**IMC EMERGENCY DEPARTMENT - X-RAY #2 - UPGRADE**  
INTERMOUNTAIN HEALTHCARE  
5125 SOUTH COTTONWOOD STREET, MURRAY UT 84107  
PERMIT SET / BID SET

REV	DATE	DESCRIPTION
1	6/17/20	ADDENDUM 01

## Electrical Addendum #1

**Date:** June 16, 2020  
**To:** Carlos Liñan  
**Company:** VCBO Architects  
**Job:** IMC Emergency Department X-Ray #2  
**Job No:** 200310  
**Cc:**

**1 L1 POWER PLAN**  
SCALE: 1/8" = 1'-0"

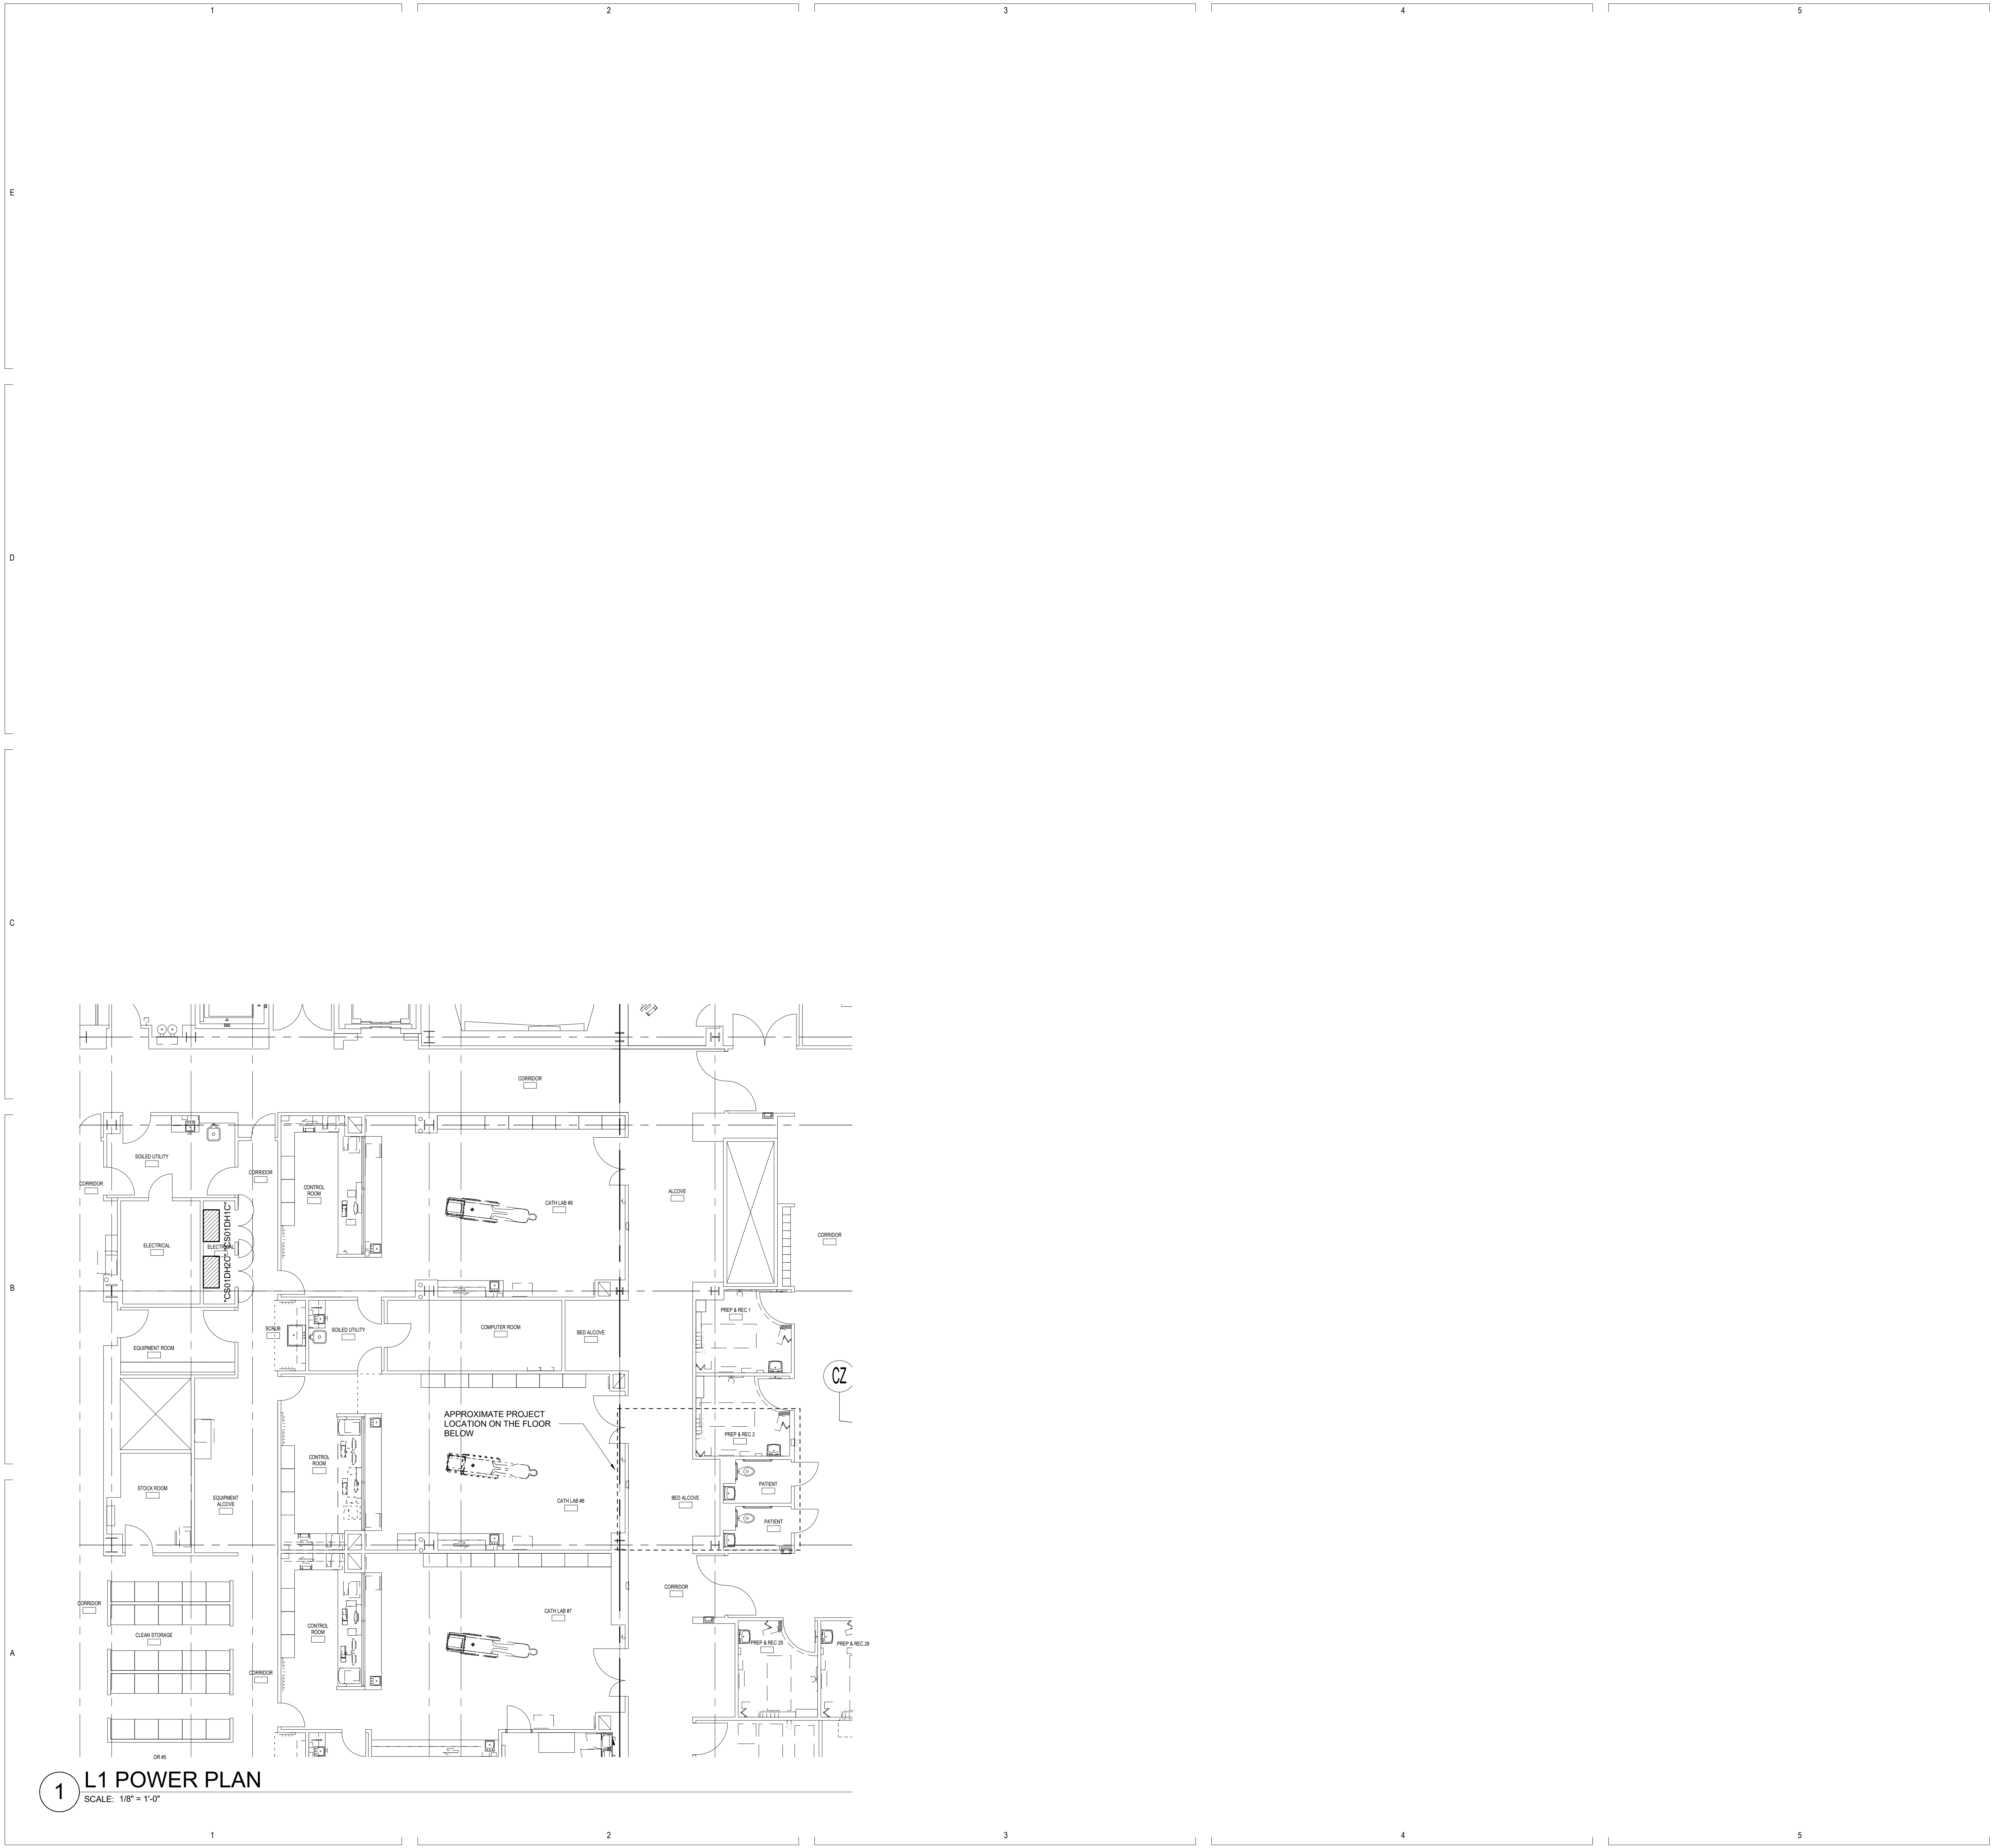
4. If the power feed needs a complete new wire run, where does it originate from so we can get a distance?

1. EP100 – L-1 Power Plan
  - a. Added sheet to show location of existing distribution panels feeding X-Ray equipment.
2. EP101 – Electrical Plans
  - a. Added fixture tags to two can lights.
  - b. Changed X-Ray in use sign to new.
3. EL601 – Lighting Schedules
  - a. Removed other fixture options so we will match the existing X-Ray room.
  - b. Added the X-Ray in use sign.

**Power is fed from the floor above. Refer to the attached sheet EP100.**

1 LL-1 LIGHTING PLAN  
SCALE: 1/4" = 1'-0"

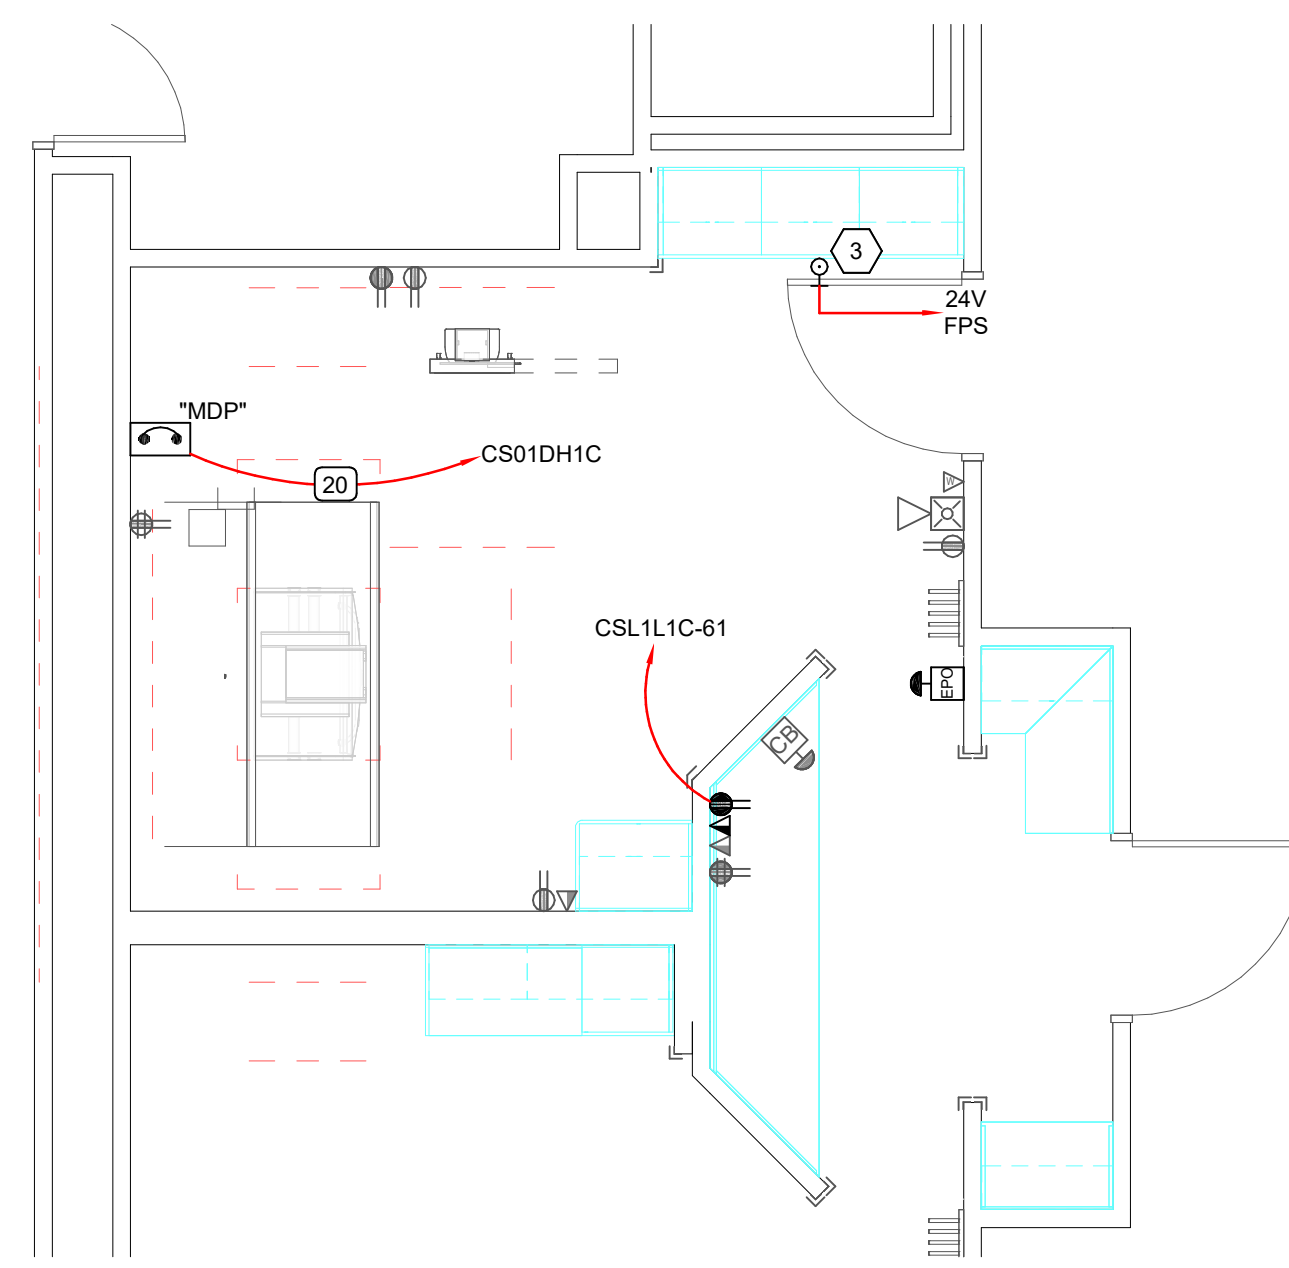
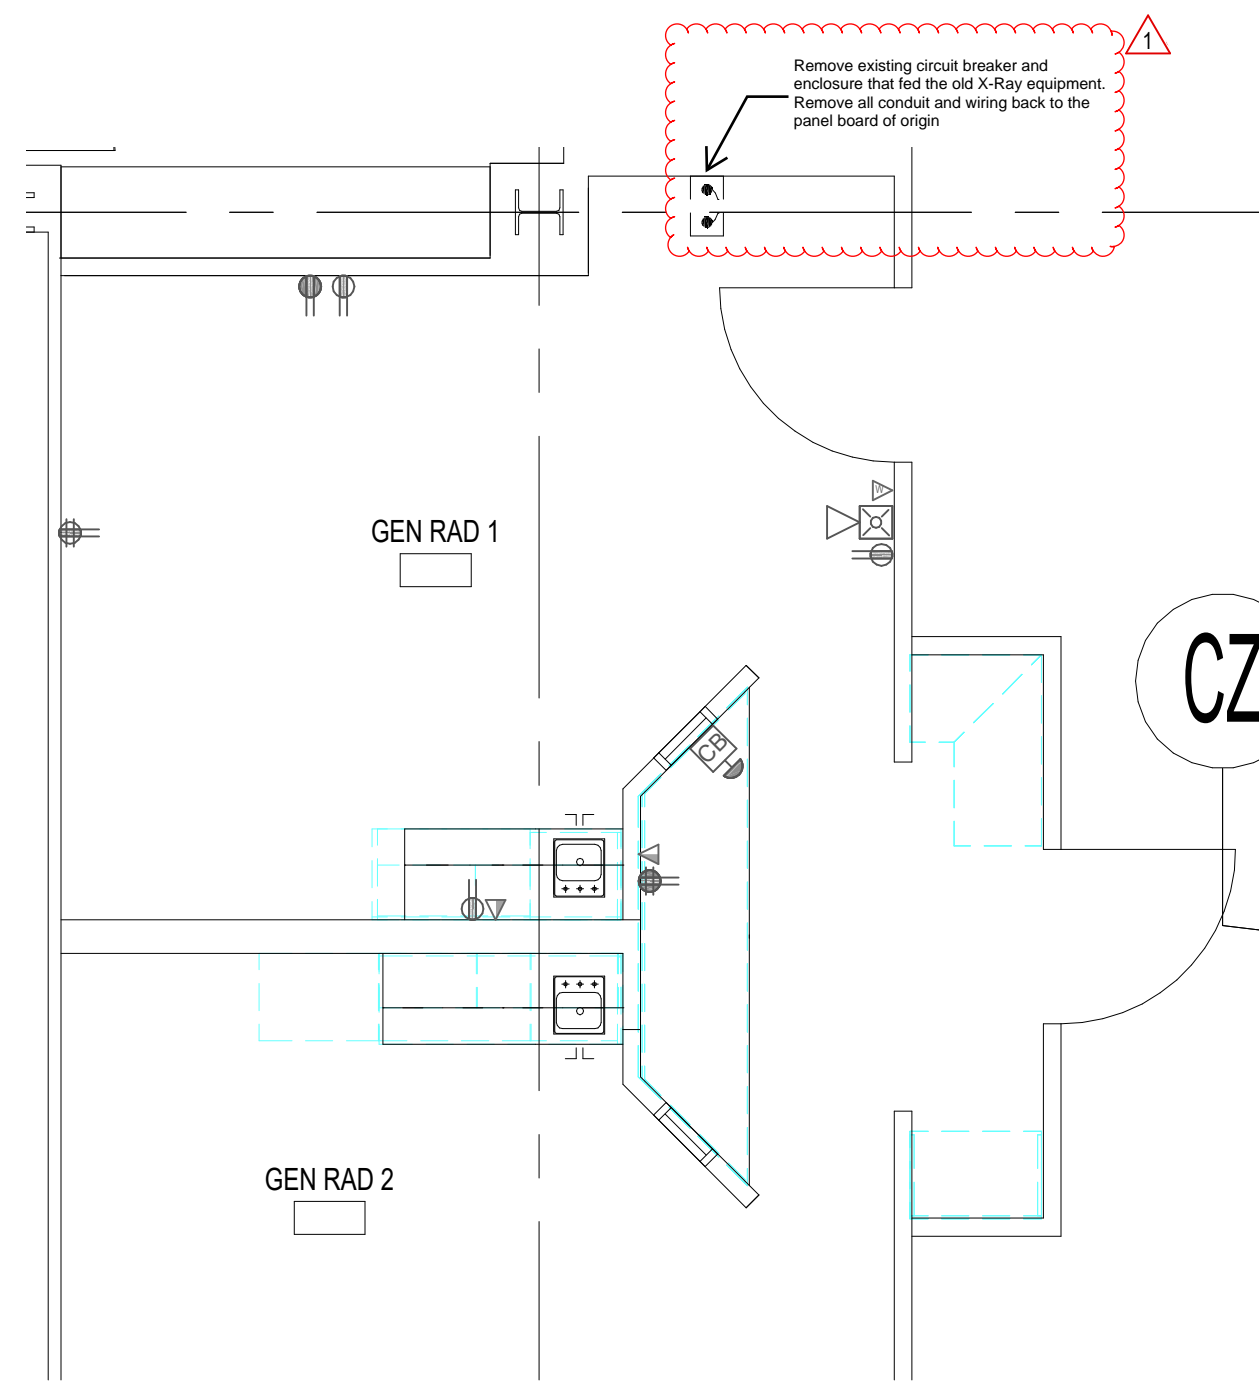
5. The lighting plan shows DX2 recess fixtures in the x ray room. The entry to the x ray room shows (2) recess can symbols that are not marked. Are these existing or are they new?

**These are two new DX-2 fixtures. There is one existing to remain fixture above the control desk for the other X-Ray room as well.**
